DEIR FINAL DISCUSSION AND SUMMATION

Alon Perlman, January 30, 2009 (Letter P40)

Exhibit 5.4-1
Faults and Surface Features
CITY OF SAN LUIS OBISPO • LOS OSOS WASTEWATER PROJECT
GEOLOGY EXPANDED ANALYSIS SECTION

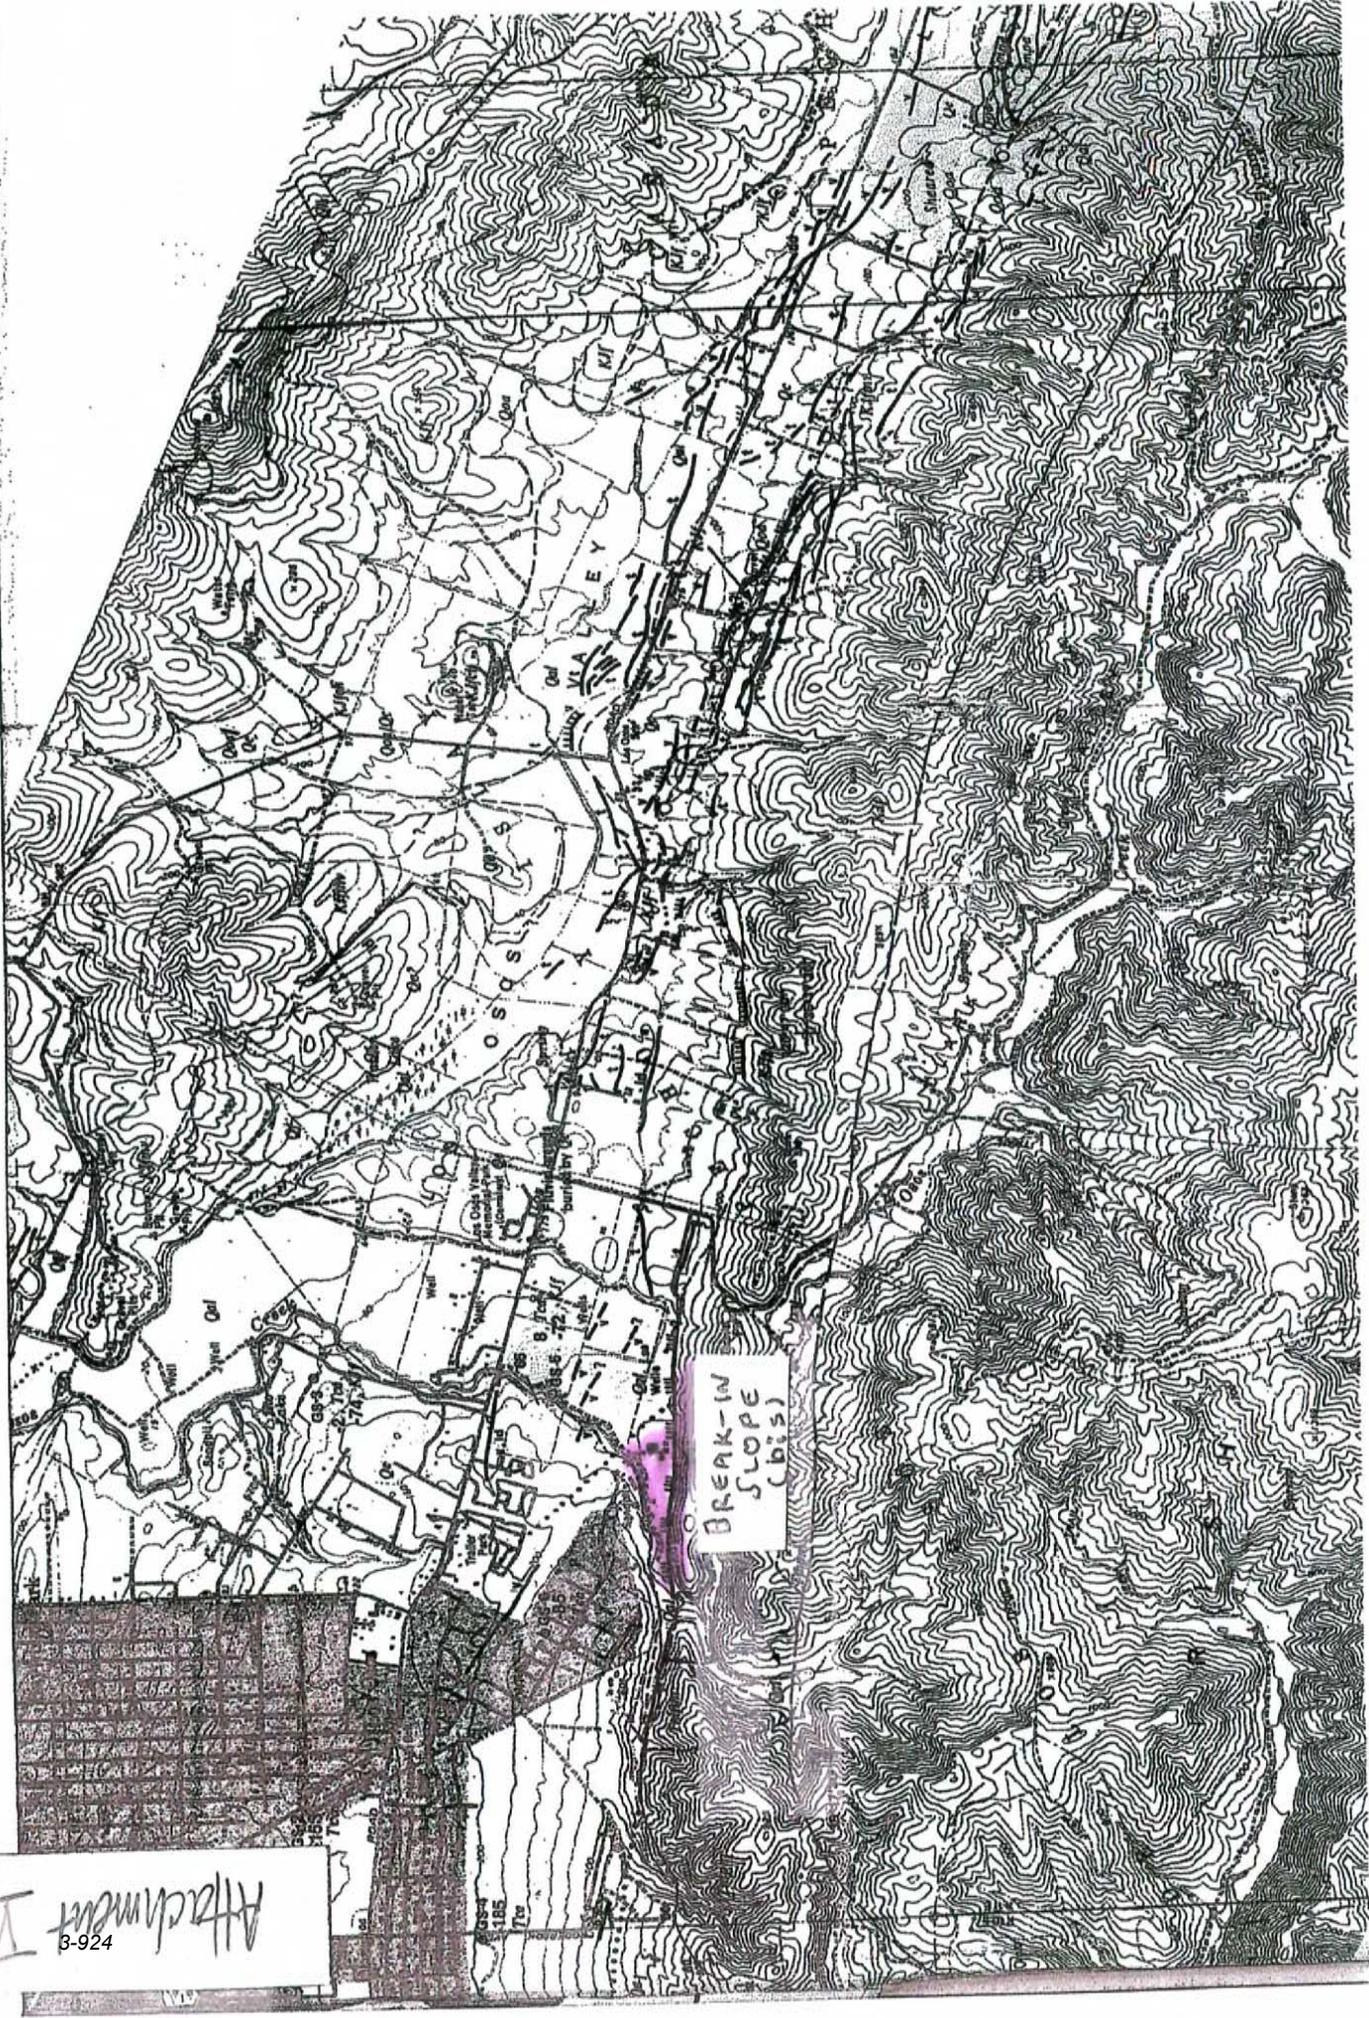
Strand A of the Los Osos Fault is shown to bisect the property in Exhibit 5.4-1 Faults and Surface Features shown as Attachment VII. In fact, this an inferred fault because the fault line as shown is based upon questionable fault traces. At the Gorby site a break-in-slope (bis) is of uncertain origins, this bis may be associated fault presence; however it may also be an erosional feature. The only way to verify the origin of the bis and the potential presence of a fault is to conduct field testing. This field testing has not been done to date, please see Attachment VIII, P.G. & E. 1988 Fault Mapping of the area.
